TITLE: String Amplitude detection		REV: 1.0
嘉立创EDA	Company: Your Company	Sheet: 1/1
	Date: 2022-11-10	Drawn By: rjuna

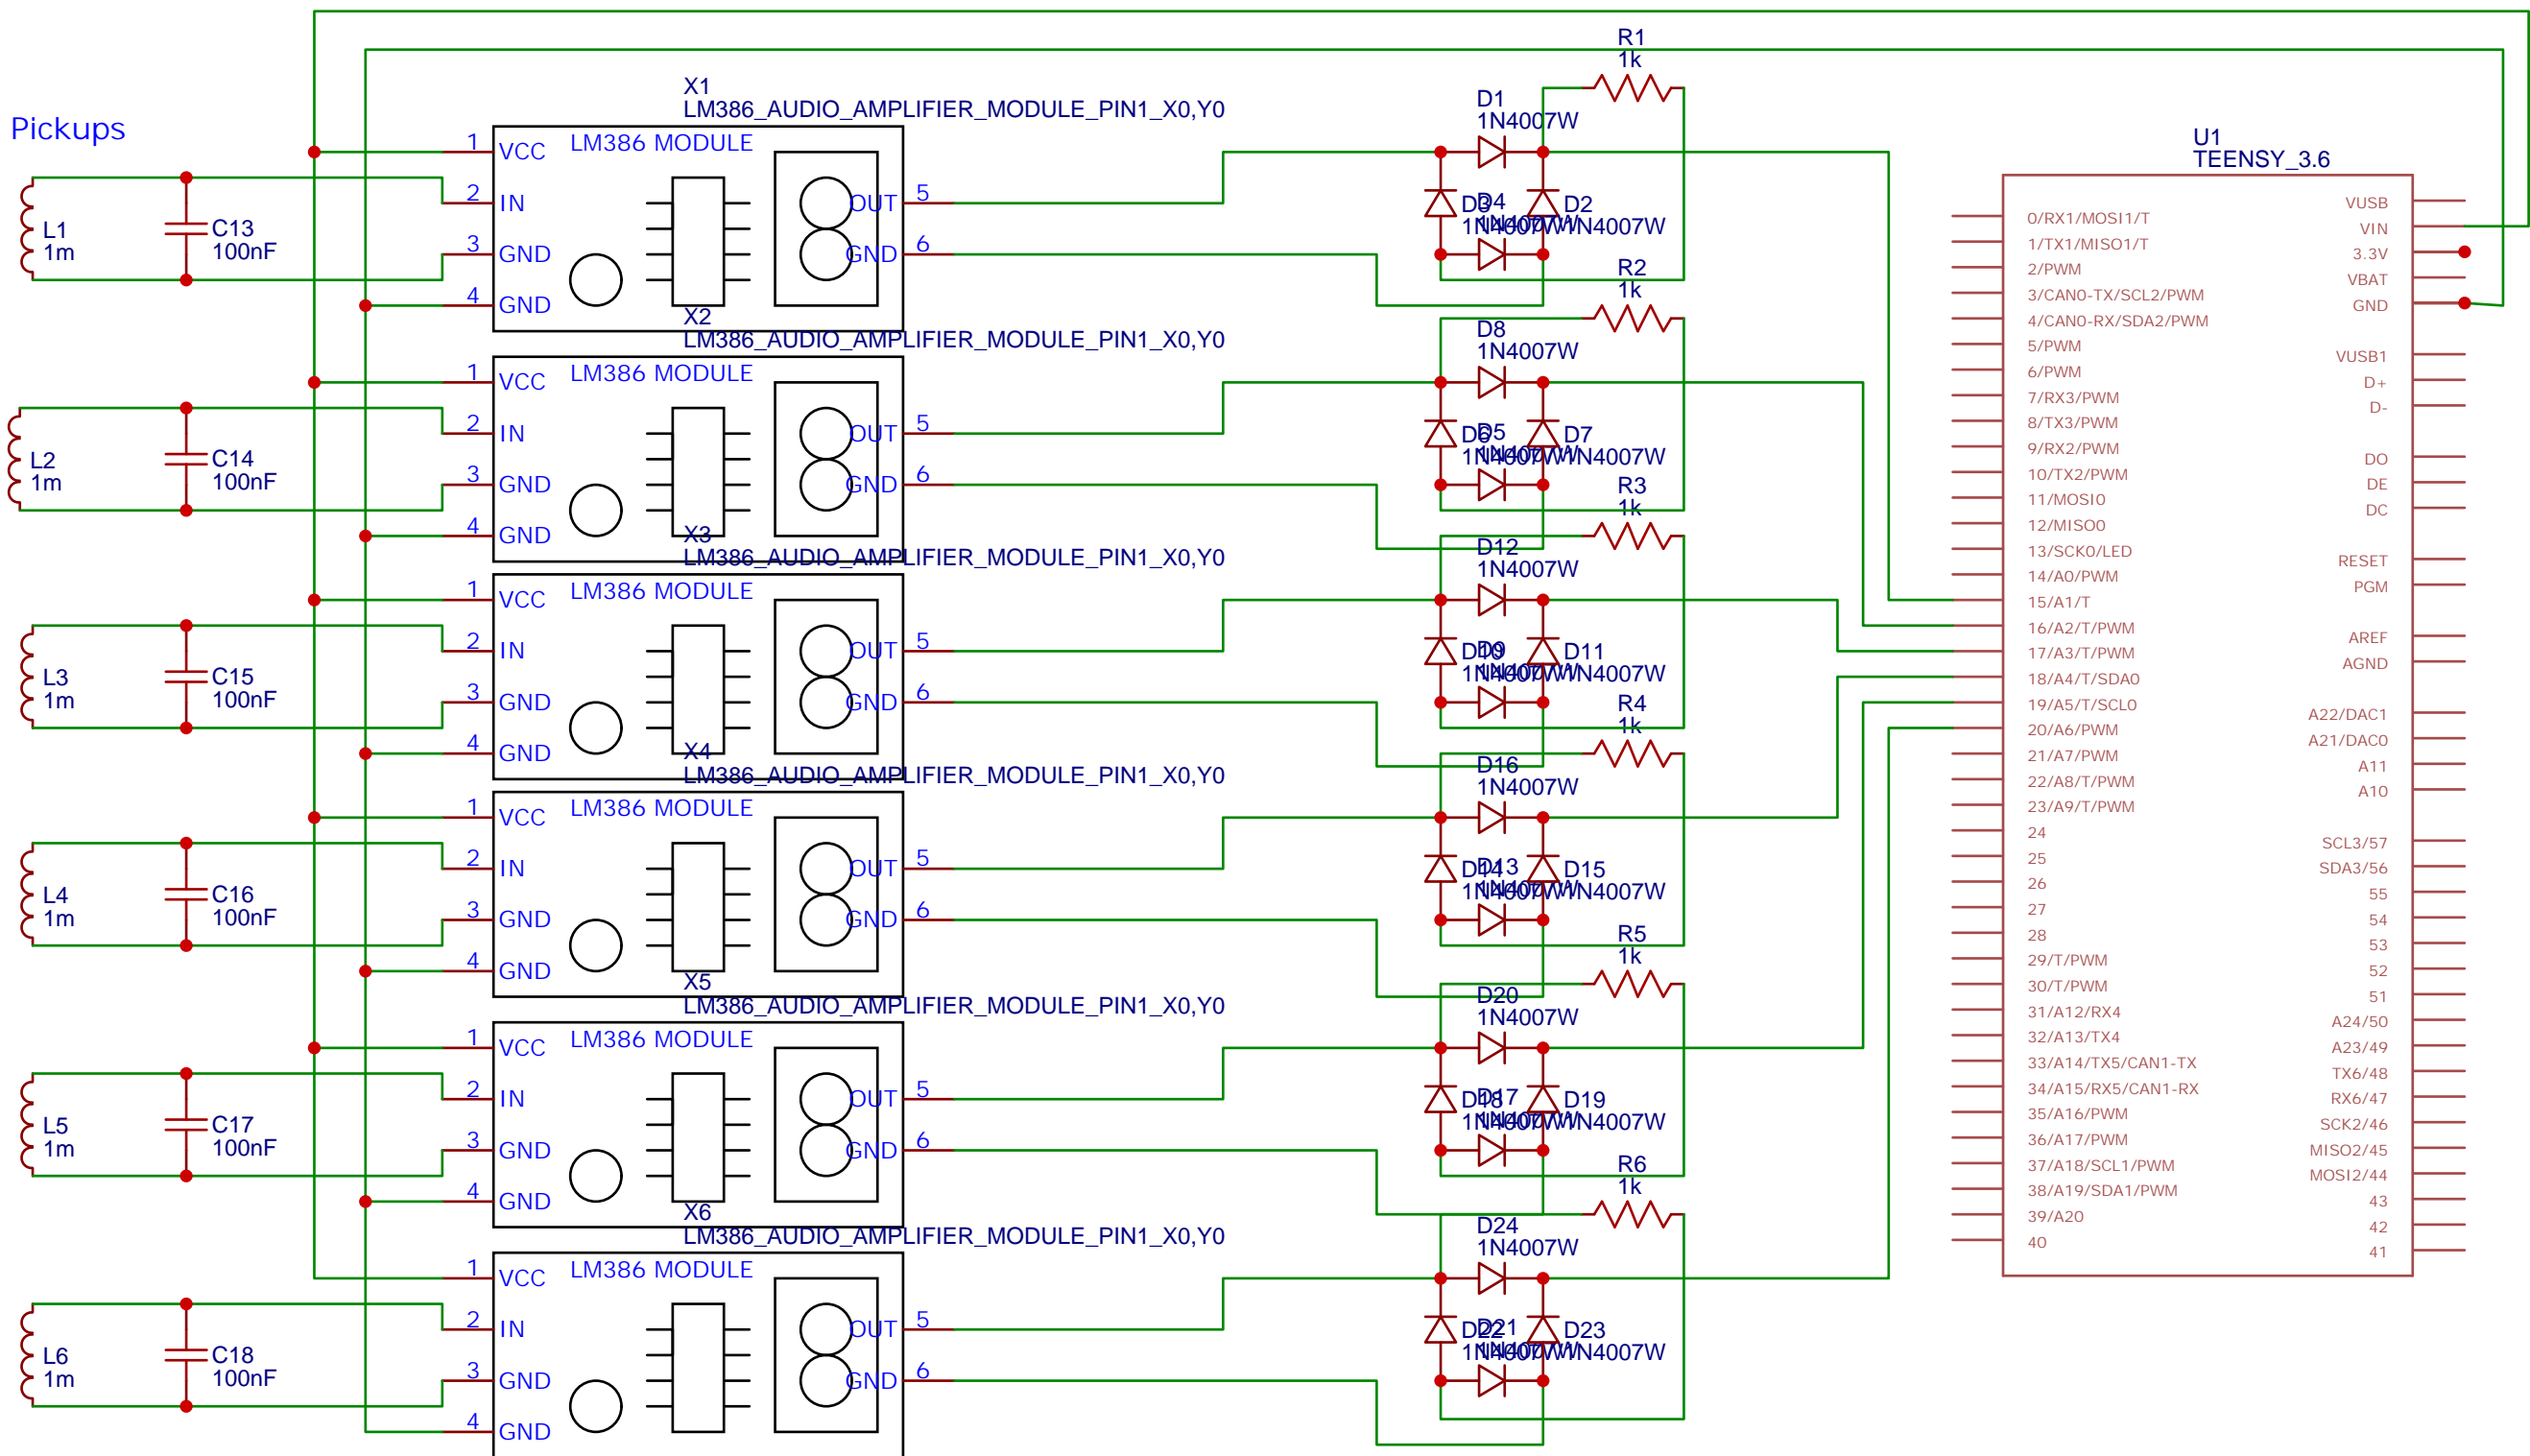
NOTE: C1 values should be reviewed for each string. C2 placement should be reviewed, maybe a resistor would be better instead

NOTE: Value of R1-R6 should be reviewed.

NOTE: A capacitor between the other two ends of the bridge rectifier (the ones not connected with R1) might further clean the signal
